PROJECT **123A90 - HOLLANDSE KUST NOORD WIND PARK**
BLPH Project

MECHANICAL COMPLETION DOSSIER (ONSHORE)

Junction Box 00-JE-12002 and Multi-core cable (PCS System)

CROSSWIND	123A90 - HOLLANDSE KUST NOORD WIND PARK BLPH Project MECHANICAL COMPLETION DOSSIER INDEX	ROSETTI MARINO

C30002543

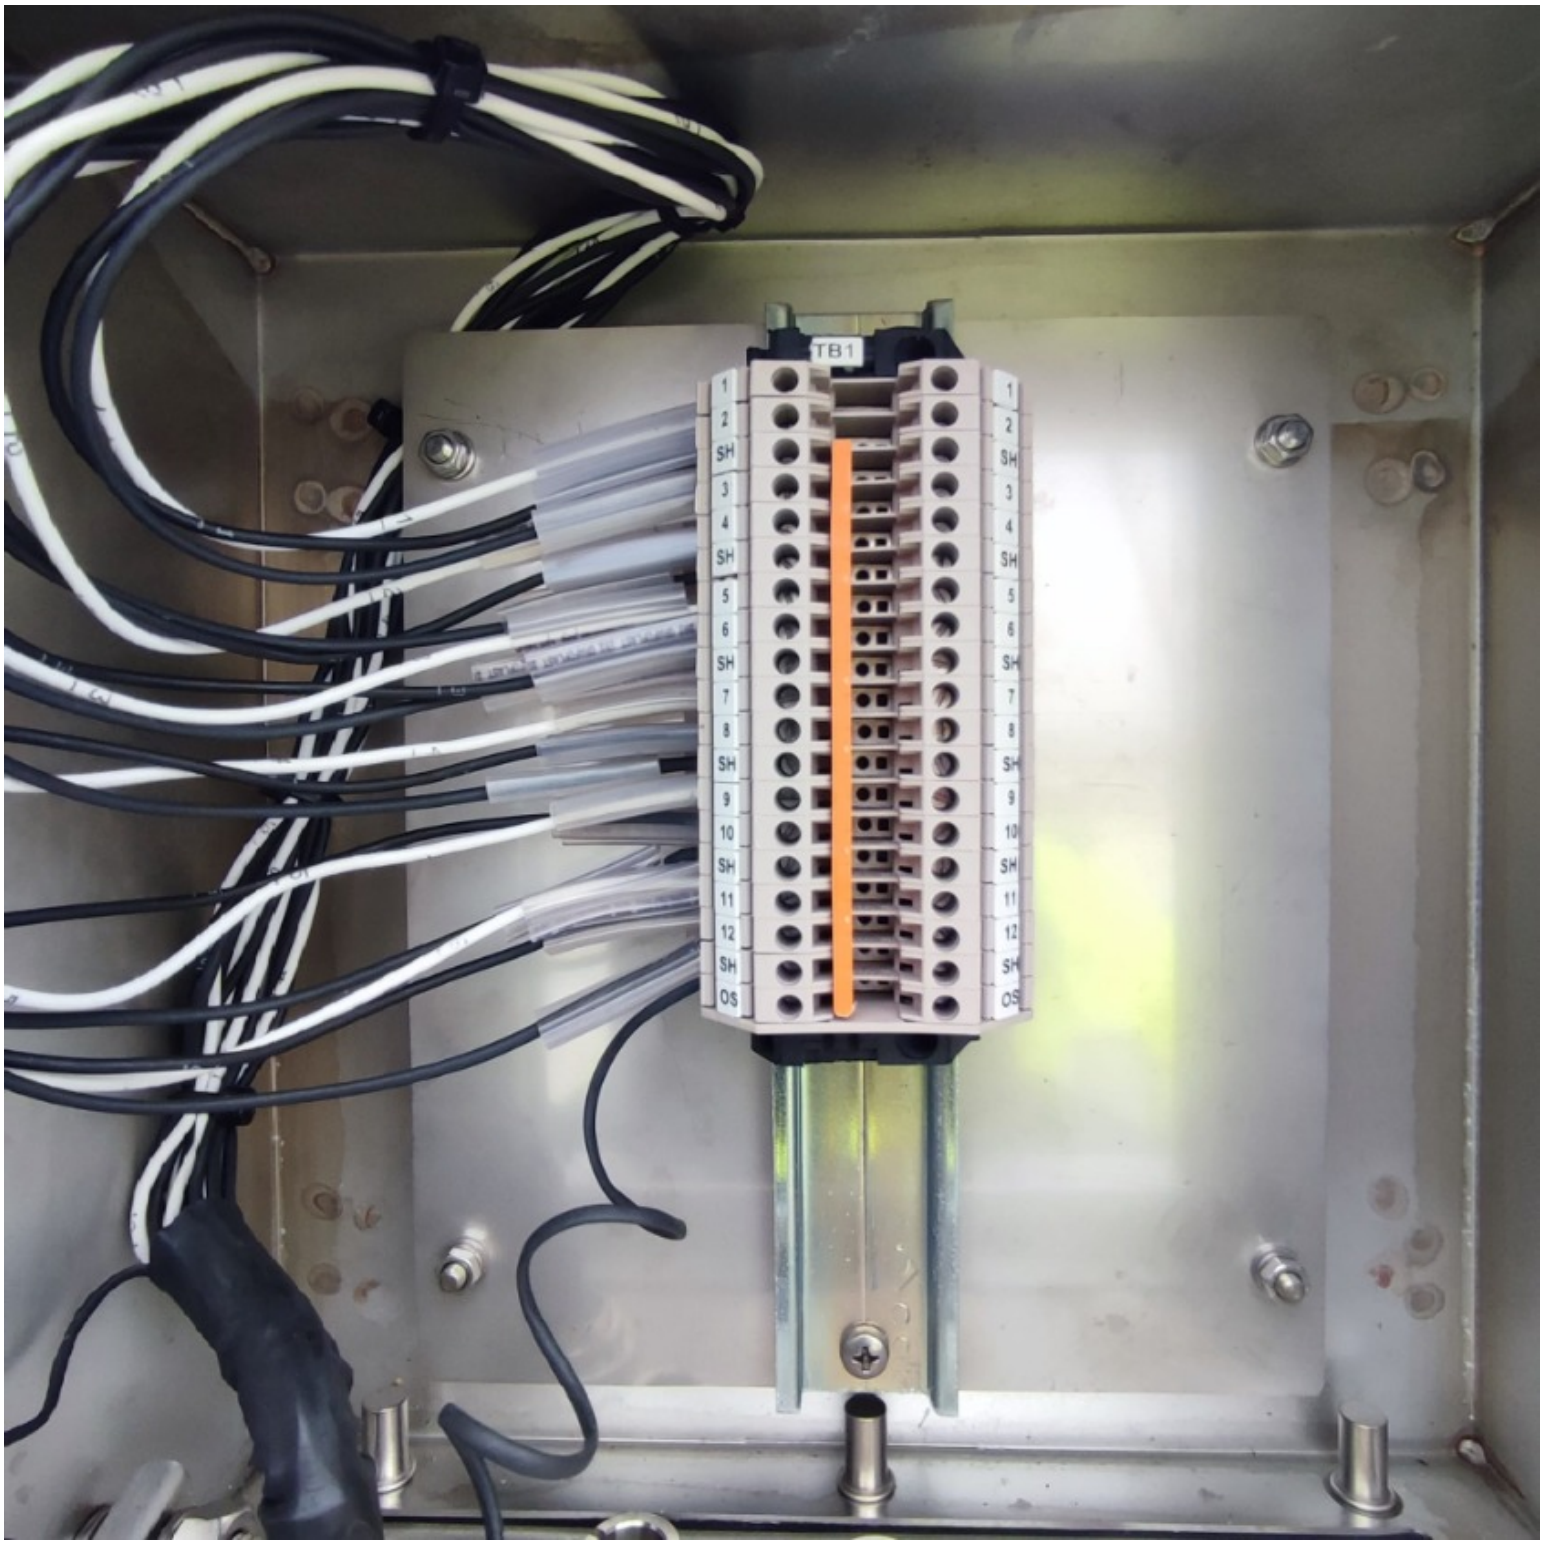
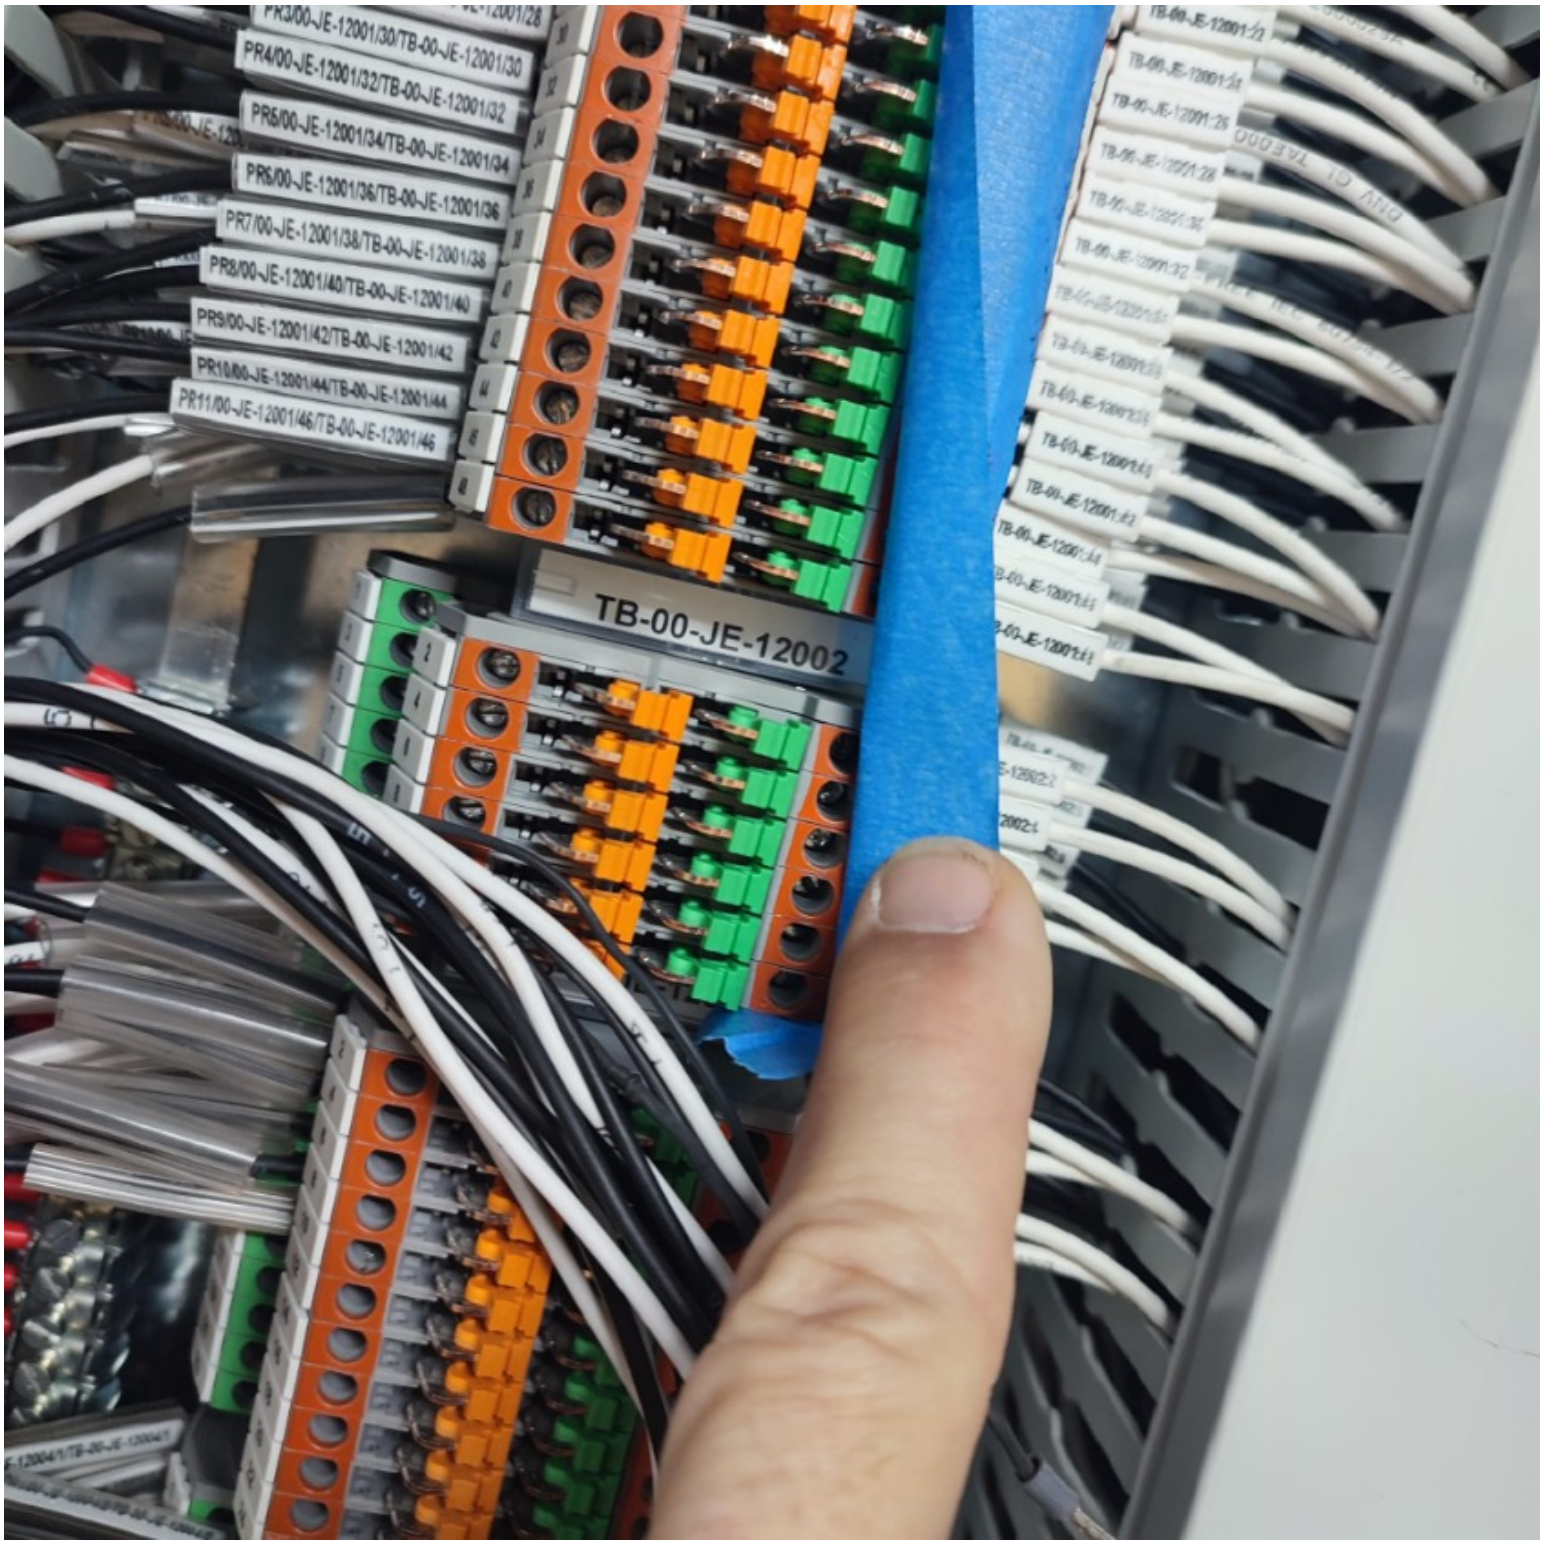
Core identification tags are missing both side (00-JE-12002/B400-PCS-00).. See attached photo.

Installed.

C30002544

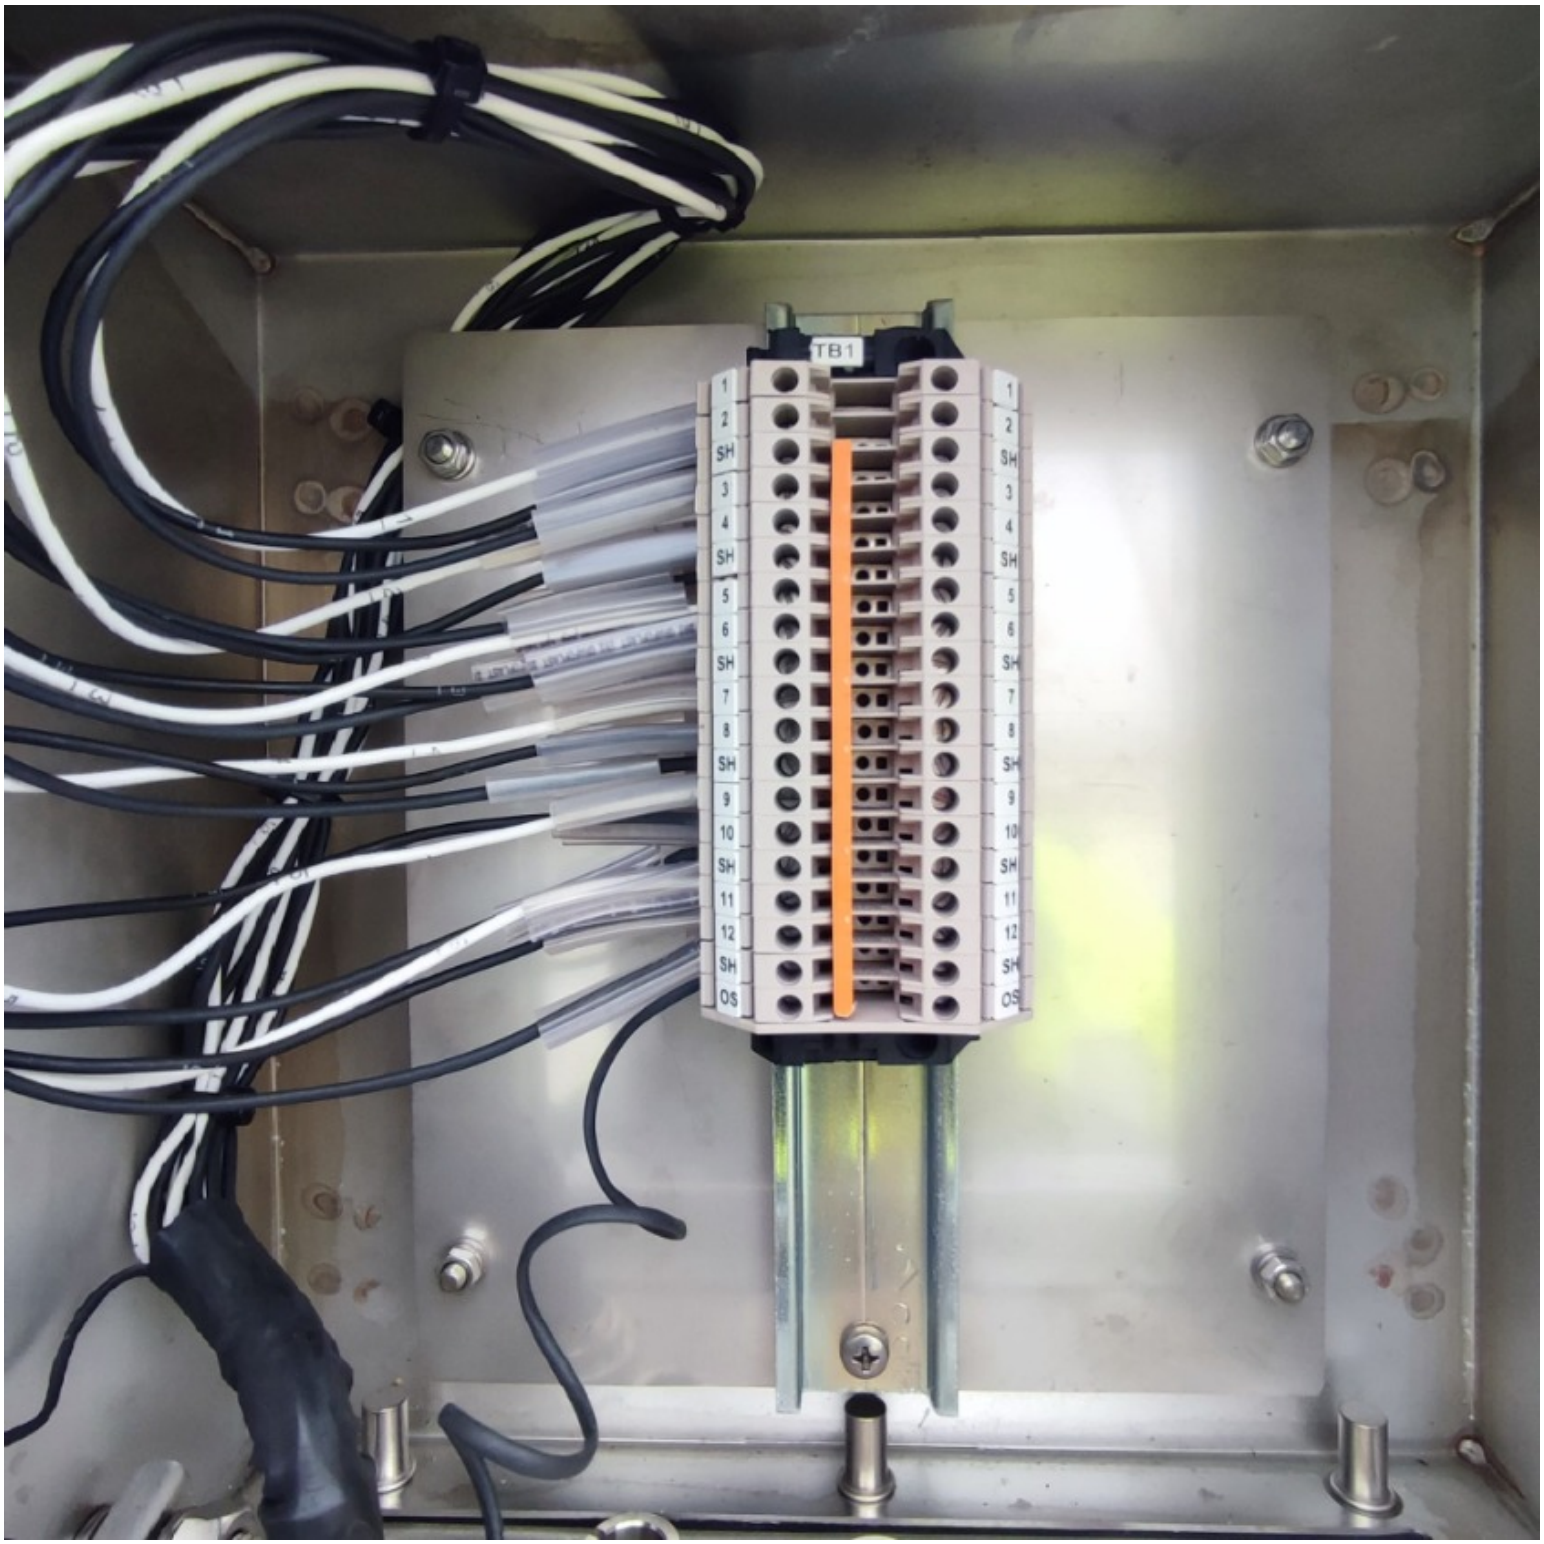
Missing grafoplast and tag wire on the shield (OS), inside the (950-JE-02102).See attached photo.

Installed.

C30002509

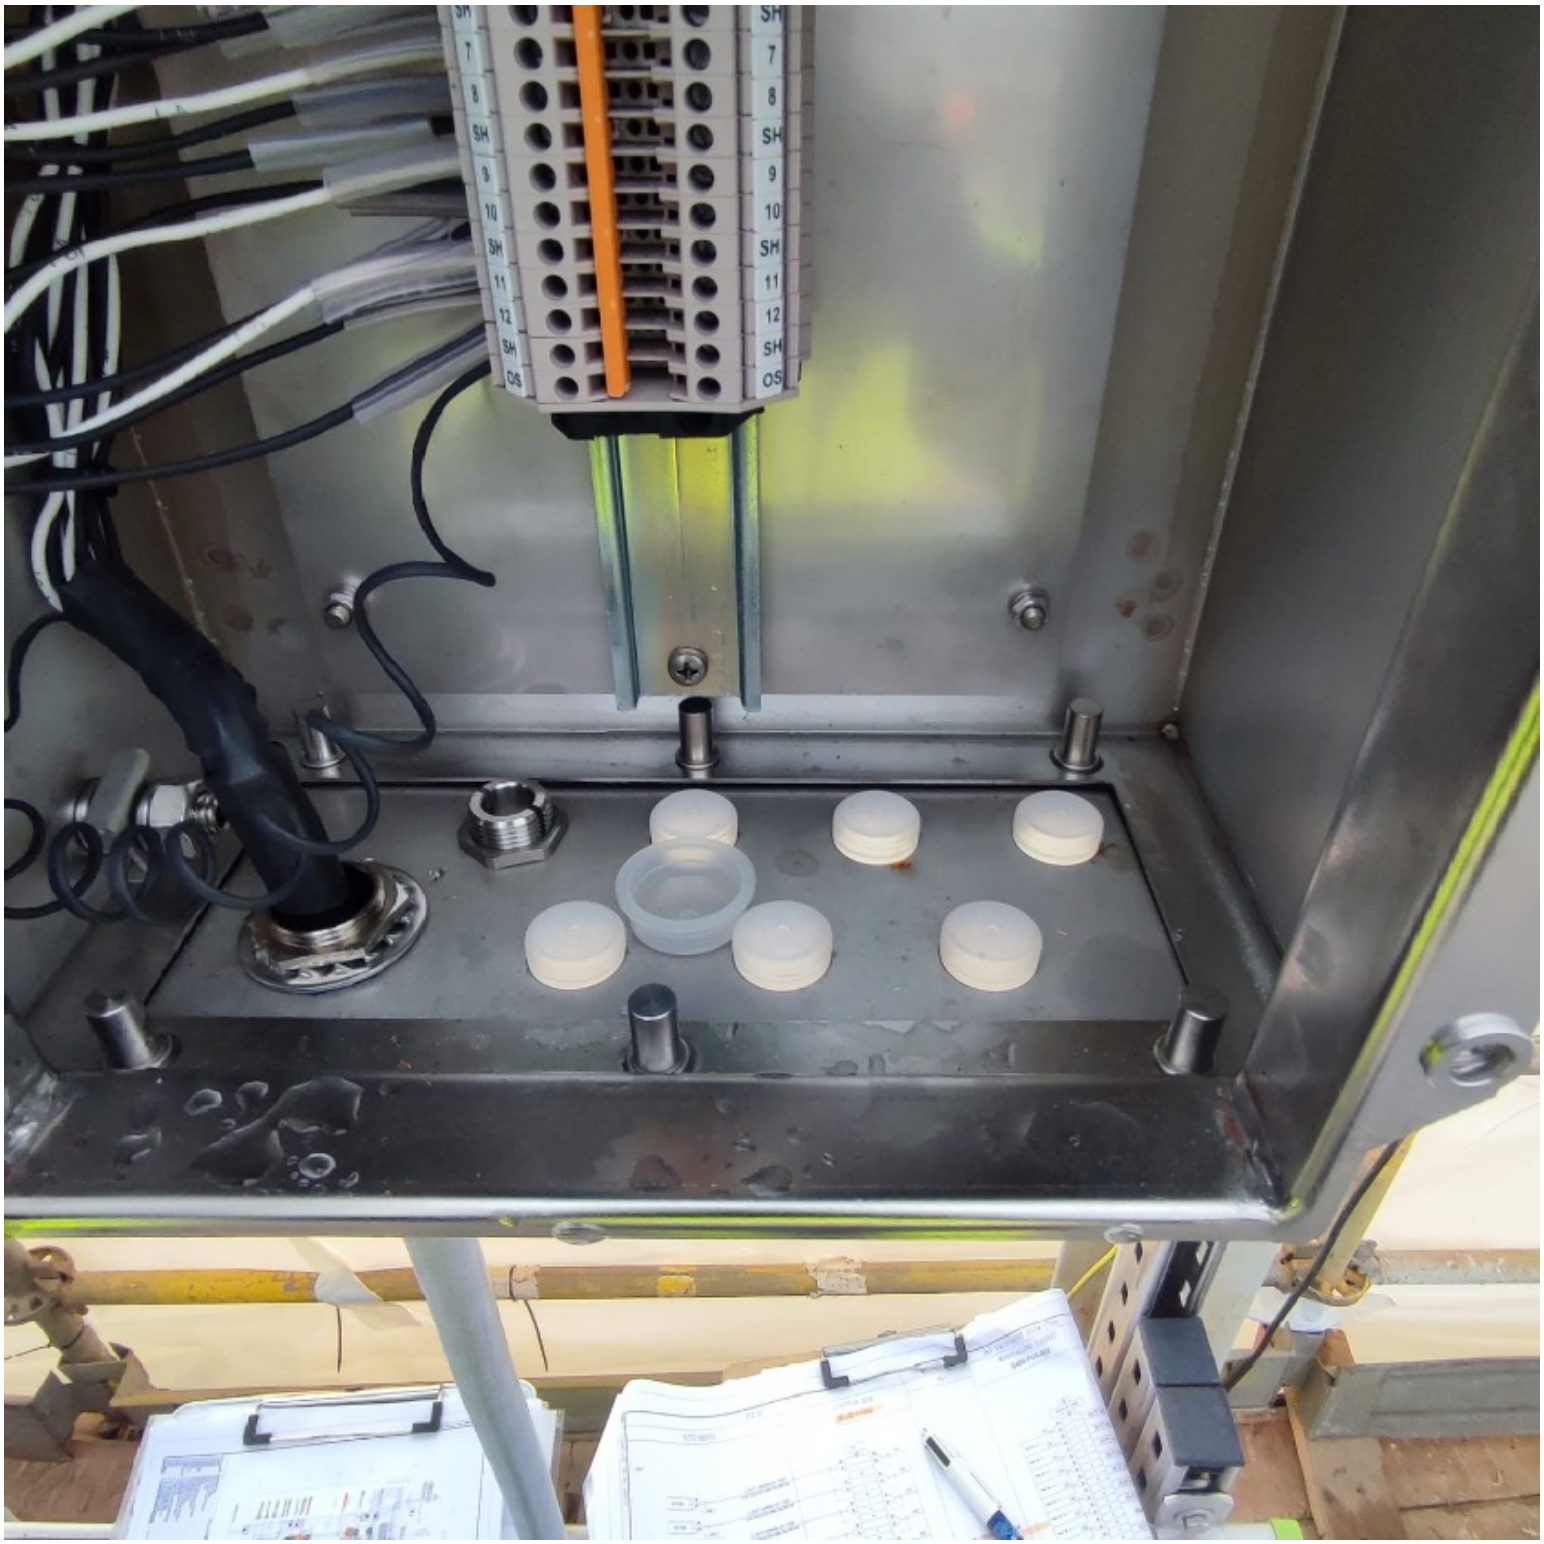
Missing certificate plugs inside the JB. See attached photo.

DONE
